**RE: Concept Application 2018SNH022/LDA2018/0172
45-61 Waterloo Road, Macquarie Park**

We write on behalf of the Applicant, John Holland Macquarie Park Land Custodian Pty Ltd (JHG), in respect of development application LDA2018/0172 which relates to 45-61 Waterloo Road, Macquarie Park (the Site). Specifically, we write in respect of two draft conditions of consent that Ryde City Council (Council) have proposed, being Conditions 13 and 25(c).

LDA2018/0172 - 45-61 Waterloo Road, Macquarie Park
Comments on Draft Conditions of Consent

Figure 4 – Area relating to Draft Condition 25(c) shown in pink below.

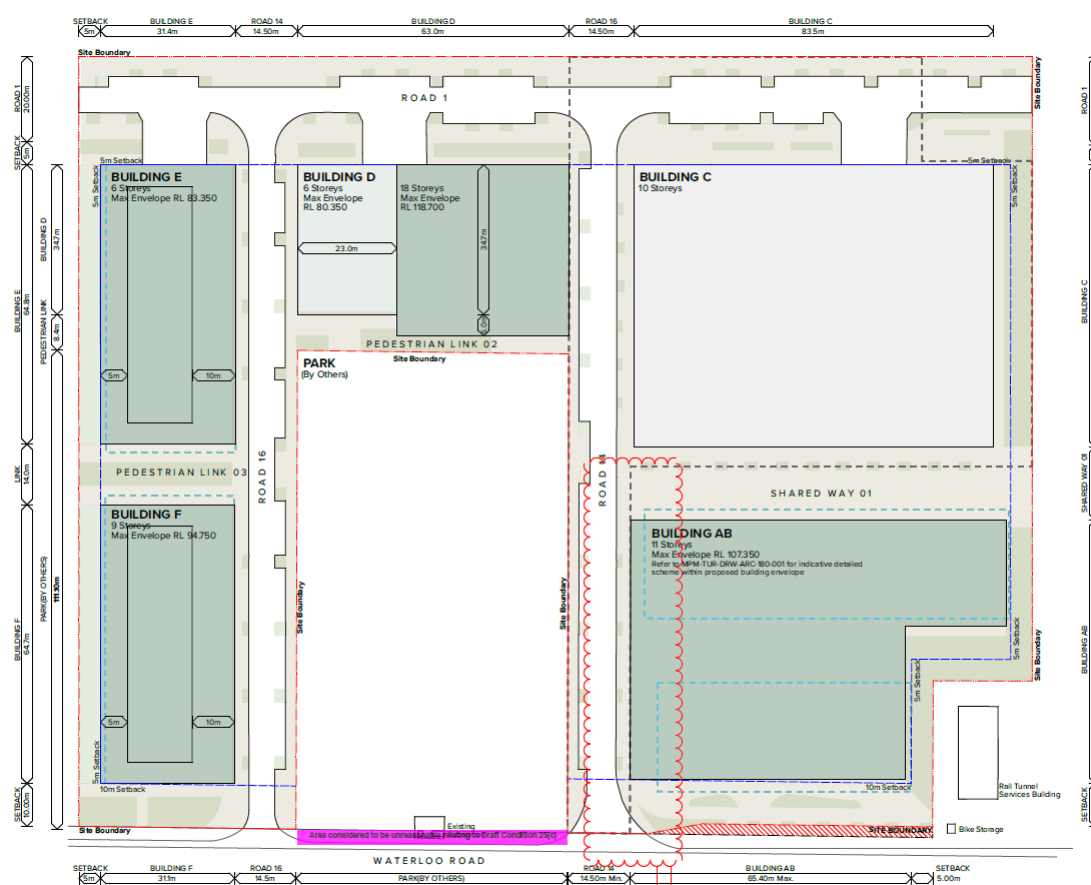
- a) There must be nexus between the imposition of a condition requiring a contribution to public works and the needs generated by the proposed development. JHG is not proposing any works along the Waterloo Road frontage that aligns the southern edge of the future Council park and there is no direct connection between that section of land along Waterloo Road and the development proposed (Refer to **Figure 4**).

- e) It would be highly unusual and irregular for a condition to be imposed requiring the upgrade of public domain that has no direct/physical connection to the development site.
